ADDENDUM

RFB NO. 315050 - ADDENDUM NO. 1

CNG GARAGE RETROFIT

DANE COUNTY PUBLIC SAFETY BUILDING
 CNG PARKING GARAGE RETROFIT
 ADDENDUM #1

BR
 ME102

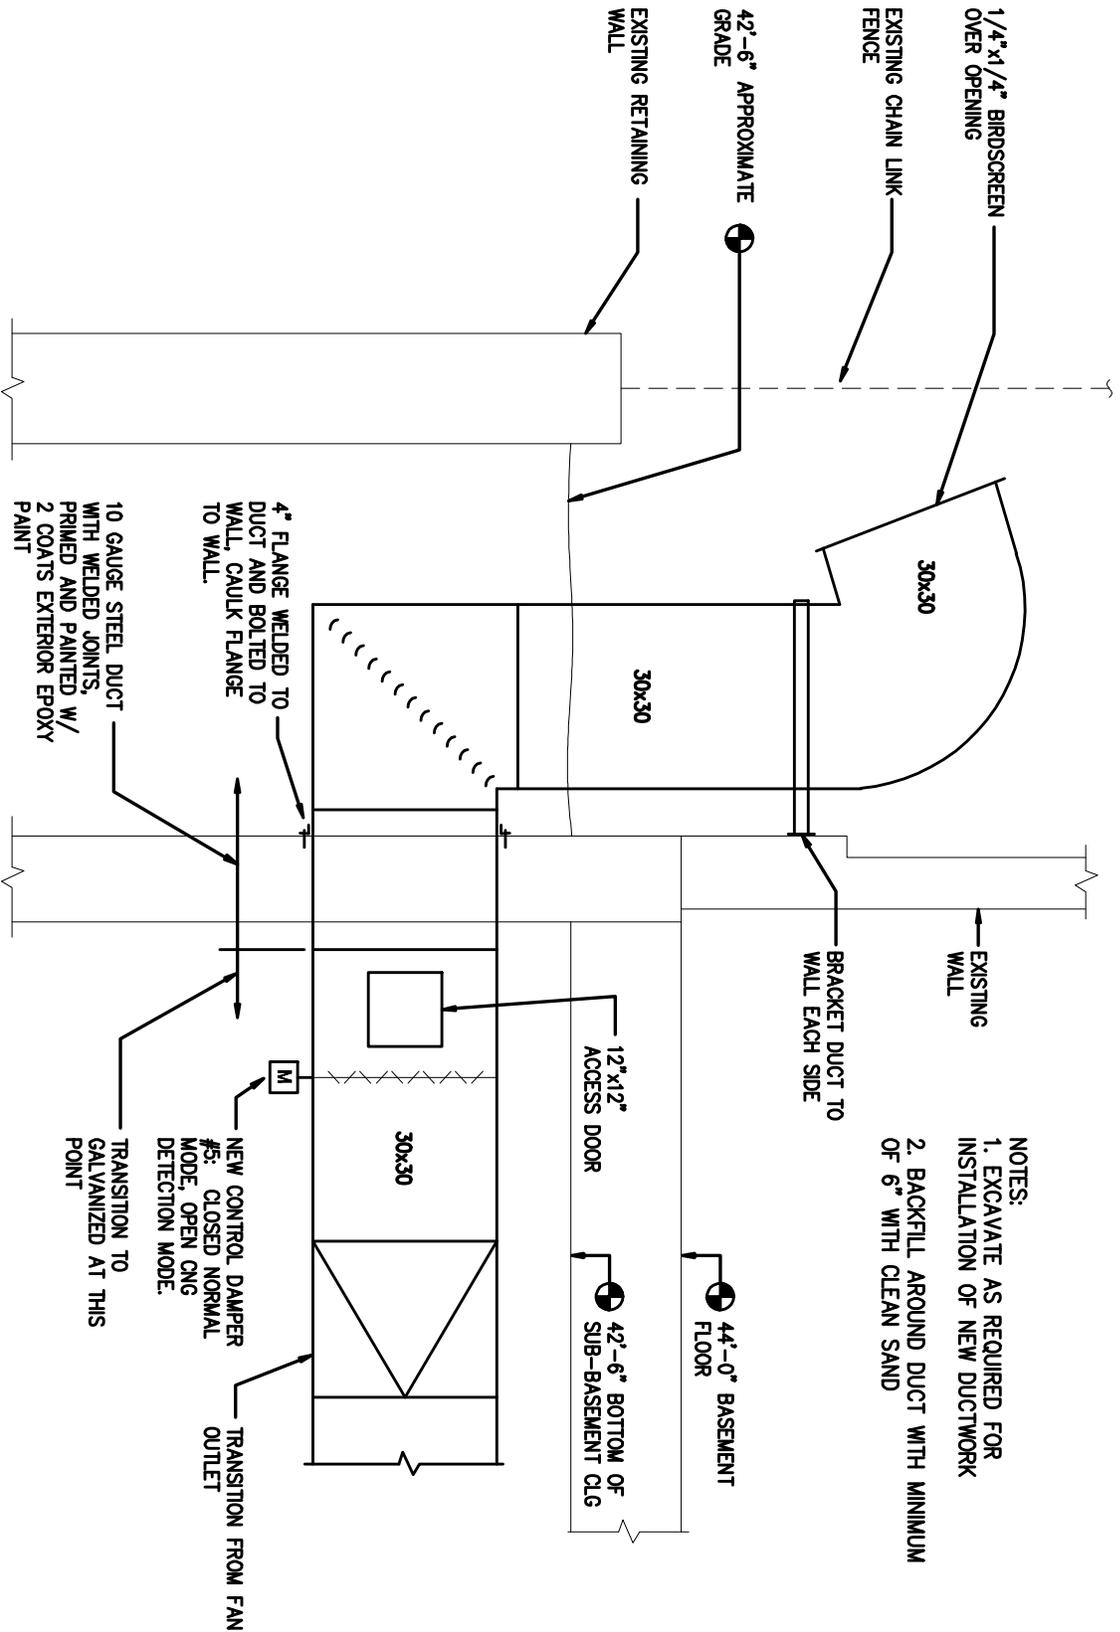
2. Add Discharge Duct Detail Drawing (ME 102)

ME101 Parking Floor Plan: At Exhaust Fan EF-1A delete ductwork shown from the outlet of EF-1A to the discharge at concrete retaining wall. Replace this ductwork with the duct as detailed in new detail BR-ME102 which is included in this addendum.

Mechanical Key Notes: Delete the keynote 12 and replace with “SEE NEW DETAIL BR-ME102 FOR REVISED EF-1A DISCHARGE.”
